I20: 60% Ground Floor Window Requirement Facing Open Areas

Parks Bureau request to require ground floor windows facing open spaces, similar to street-facing facades

120: 60% Ground Floor Window Requirement Facing Open Areas

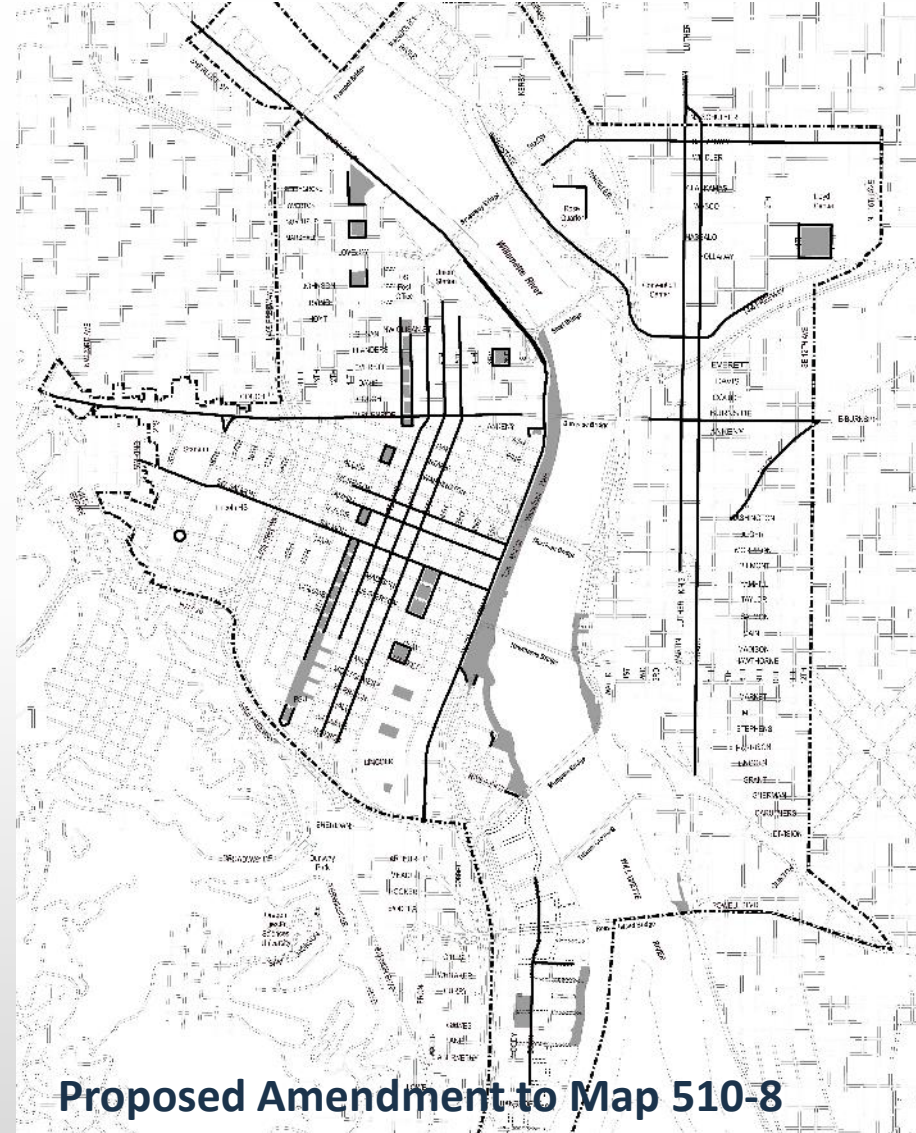
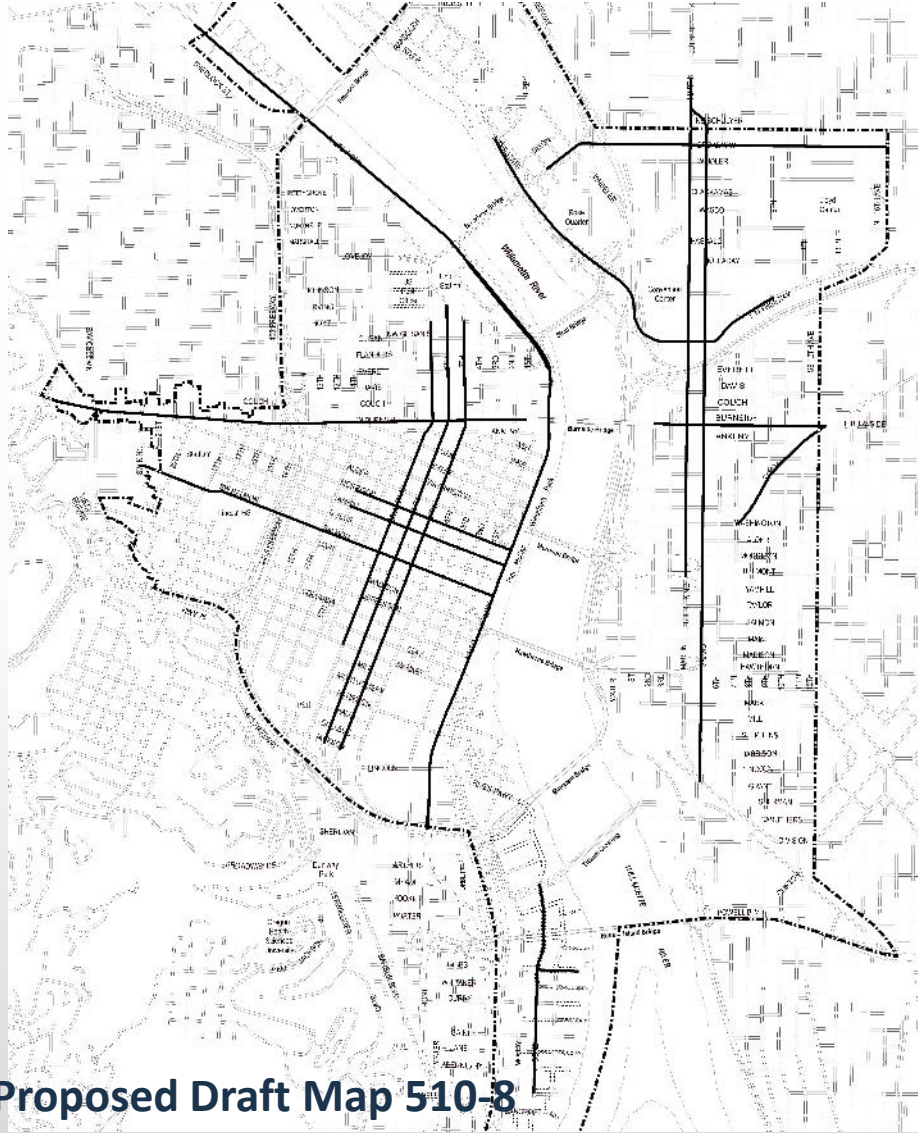
- Better activation of open spaces
- Enrichen pedestrian experience, public realm
- “Eyes on the park”
